GRANADA RIDGE DEVELOPMENT

TEXAS POLLUTANT DISCHARGE ELIMINATION SYSTEM

CONTRIBUTING ZONE PLAN MODIFICATION

February 2025

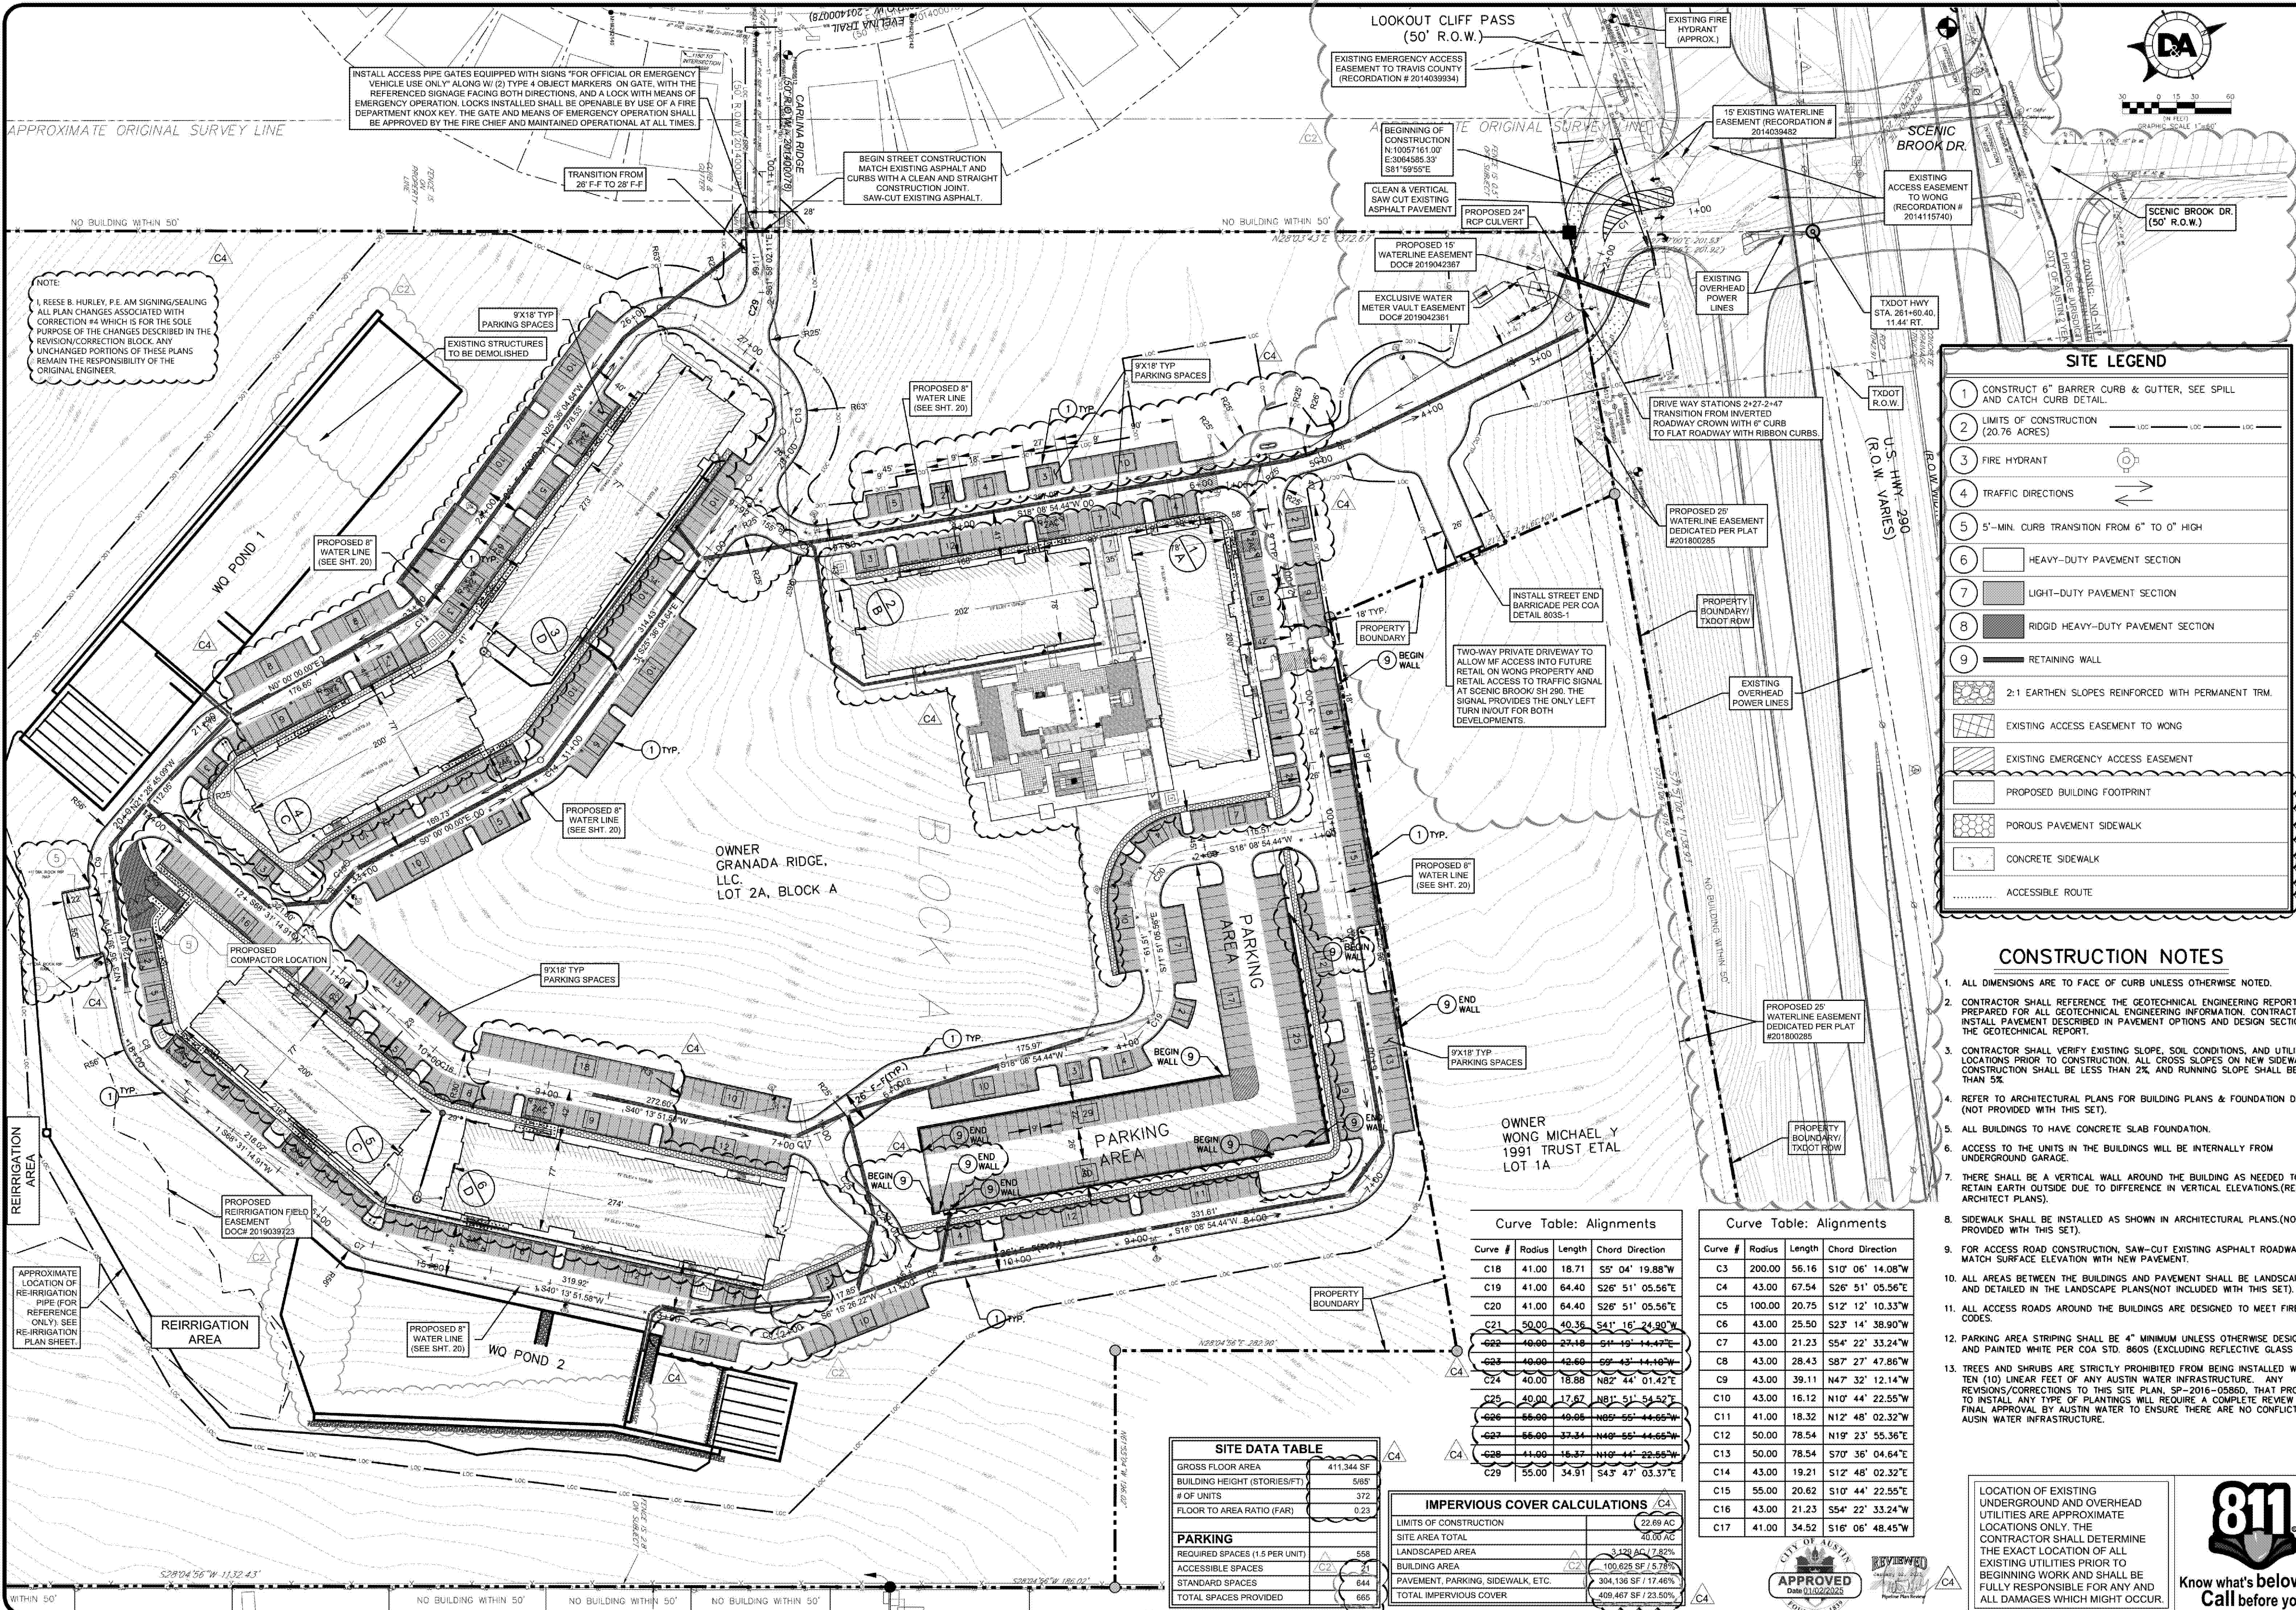
The total building coverage is decreasing with this correction, allowing for additional impervious cover from the added surface parking, sidewalks, and amenities draining to Pond 2. Also, permeable sidewalks in lieu of concrete sidewalks are proposed on parts of the site to keep the amount of impervious cover draining to Ponds 1 and 2 consistent with the previous correction.

Undeveloped drainage areas: UPD-2, UDP-5, and UDP-7, are being reduced by a total of 0.06 acres. As a result, the flows at point of confluences O-2 and O-3 are being slightly reduced. The change in size of UDP-7 was not significant enough to affect the resulting flows to point of confluence O-4. To offset the additional area being captured onsite from these drainage areas, UDP-3 is being increased by 0.06 acres and Drainage Area Pond #1 is being decreased by 0.06 acres. Therefore, the overall size of the drainage areas for Pond 1 and Pond 2 are unchanged.

The resulting flows at point of confluence CP #1 are increasing by less than 1 cfs for the 2-, 10-, 25-, and 100-years flows. The resulting flows are still significantly below the existing condition flows. Please see the attached replacement and redline Sheet 11 for the modified drainage areas and flow calculations.
